MANDATORY**MTL-53-02****TITLE**

FUSELAGE - FORWARD FUSELAGE FASTENER INSPECTION

MODEL	SERIAL NUMBERS
B200GT	BY-178 thru BY-395, BY-397 thru BY-406
B200CGT	BZ-1, BZ-2
B300C	FM-51 thru FM-100, FM-102
B300	FL-769 thru FL-1257, FL-1259 thru FL-1261, FL-1263, FL-1264, FL-1266, FL-1268, FL-1270 thru FL-1272

During inspection it was found that the rivets might not have been installed in the lap joint between Fuselage Station (FS) 100.50 to FS 107.00 on the left and right sides.

Figure 1. Model B200 Airplanes Rivet Installation (Sheet 1)

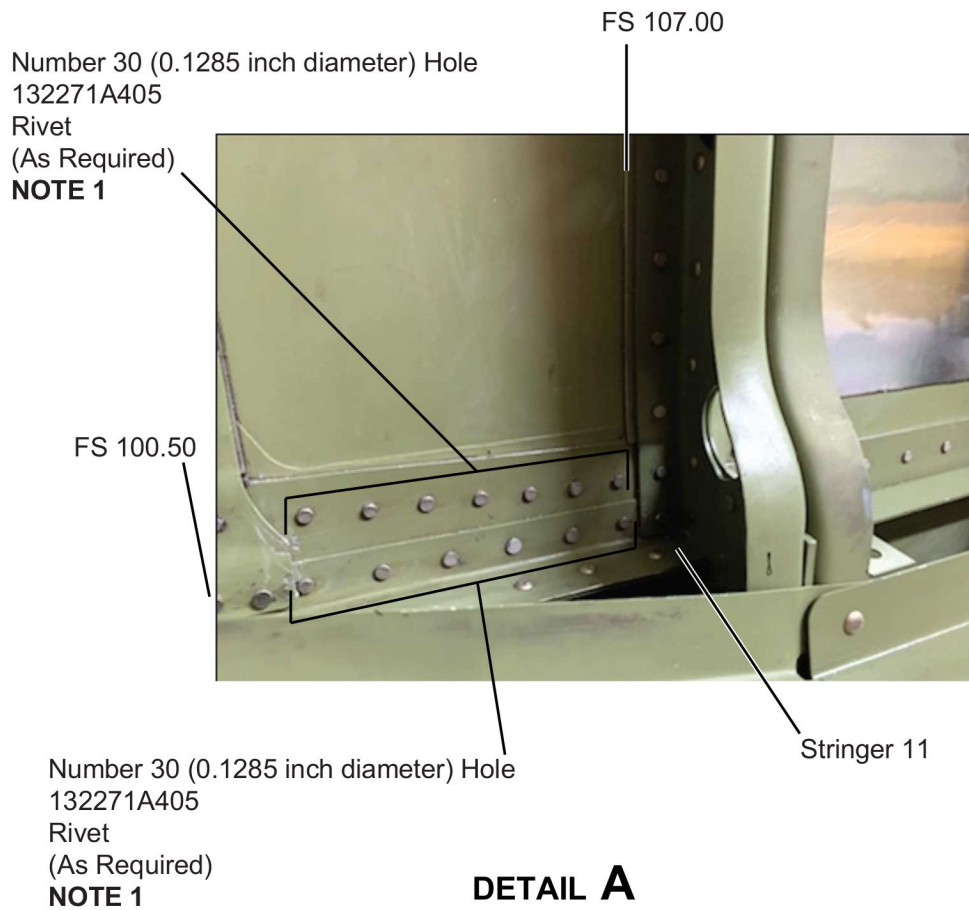
3. (Model B200 Series Airplanes, Refer to Figure 1, Sheet 1 and Sheet 2.) Inspect for the correct number of rivets installed between FS 100.50 and FS 107.00 as follows:
NOTE: FS 100.50 to FS 107.00 and Stringer 11 is located at the forward fuselage below the windscreen approximately halfway down the fuselage. The seam lines for the fuselage skin panels can be used for locating the location of FS 107.00 while FS 100.50 will be the next forward vertical row of rivets. (Refer to the applicable Model Maintenance Manual, Chapter 6, Dimensions and Areas, Airplane Stations - Description and Operations.)

- Left side top row should have 7 rivets and the bottom row should have 6 rivets.
 - Right side top row should have 7 rivets and the bottom row should have 6 rivets.

- C. (Model B200 Series Airplanes, Refer to Figure 1, Sheet 1.)
 - Left side top row should have 7 rivets and the bottom row should have 6 rivets.
 - Right side top row should have 7 rivets and the bottom row should have 6 rivets.

4. Install missing rivets as follows:
 - A. Measure and identify the center location between the rivets that have the widest space.
NOTE: The distance between adjacent rivets must maintain a minimum of 0.50-inch and the edge distance must be 1.5 times the rivet diameter.

- B. From the inboard side of Stringer 11, mark and drill a Number 30 (0.1285 inch diameter) hole as required to match the number of holes as shown in the figures through the stringer, the lap joint of the upper and lower skin, and the FOD shield.

- D. From the out board side of the FOD shield, counter sink all drilled holes to 100 degrees x 0.222 to 0.228 inch diameter.
 - E. Debur all drilled holes.

- F. Make sure all rivet shavings are removed.
 - G. Apply Color Chemical Film Treatment to all bare metal.
 - H. Apply U470637 Sealant to any required 132271A405 Rivet. (Refer to the applicable Maintenance Manual, Chapter 51, Structures - Maintenance Practices.)

- I. Install the sealed 132271A405 Rivet into any drilled hole from the outboard side of the FOD shield. (Refer to the Beechcraft Structural Inspection and Repair Manual, Chapter 20, Fastener Installation and Removal.)

Figure 2. Model B300 Airplanes Rivet Installation (Sheet 1)

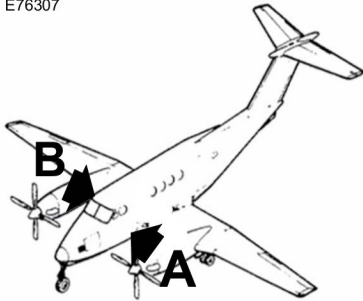
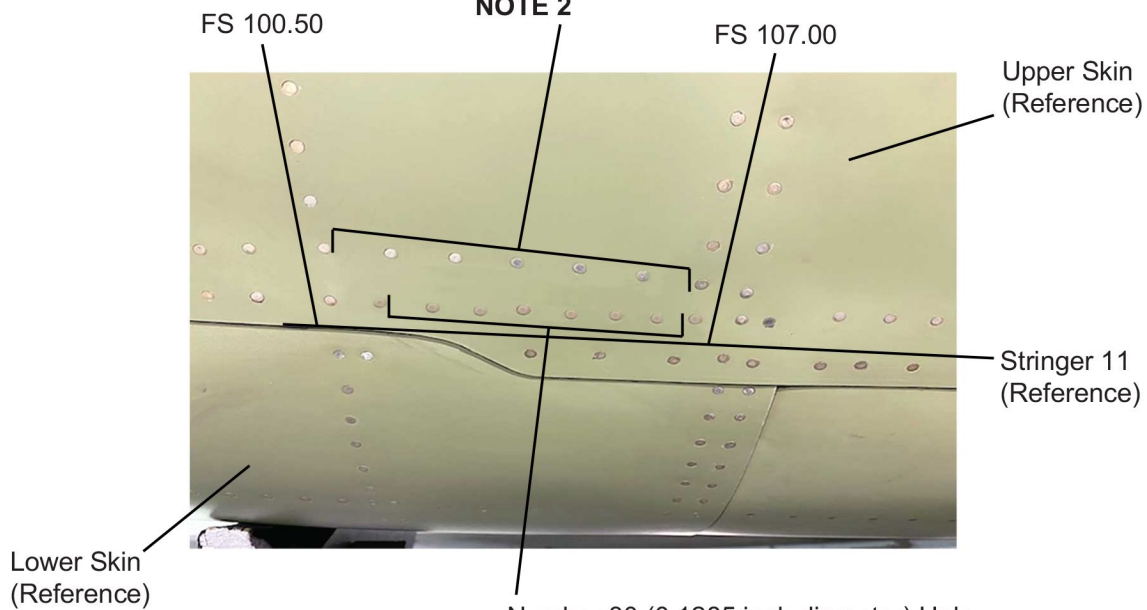
- A. If the 132271A405 Rivets were installed on either the left or right side, go to Step 9.
 - B. If the rivet count was correct, go to Step 11.
7. (Model B300 Series Airplanes, Refer to Figure 2, Sheet 1 and Sheet 2.) Inspect for the correct number of rivets installed between the FS 100.50 to FS 107.00 are as follows:
NOTE: FS 100.50 to FS 107.00 and Stringer 11 is located at the forward fuselage in line with the forward end of the windscreen. (Refer to the applicable Model Maintenance Manual, Chapter 6, Dimensions and Areas, Airplane Stations - Description and Operations.)

- (1) (Model B300 Series Airplanes, Refer to Figure 2, Sheet 1 and 2.)
 - Left side top row should have 5 rivets and the bottom row should have 6 rivets.

NOTE: The distance between adjacent rivets must maintain a minimum of 0.50-inch and the edge distance must be 1.5 times the rivet diameter.
 - B. From the outboard side of the lap joint, mark and drill a Number 30 (0.1285 inch diameter) hole as required to match the number of holes as shown in the figures through the lap joint of the upper and lower skin.

- Right side top row should have 6 rivets and the bottom row should have 7 rivets.
 - C. Counter sink all drilled holes to 100 degrees x 0.222 to 0.228 inch diameter.

- D. Debur all drilled holes.
 - E. Apply Color Chemical Film Treatment to all bare metal.
 - F. Apply U470637 Sealant to any required 132271A404 Rivet. (Refer to the applicable Maintenance Manual, Chapter 51, Structures - Maintenance Practices.)

- G. Install the sealed 132271A404 Rivet into any drilled hole. (Refer to the Beechcraft Structural Inspection and Repair Manual, Chapter 20, Fastener Installation and Removal.)
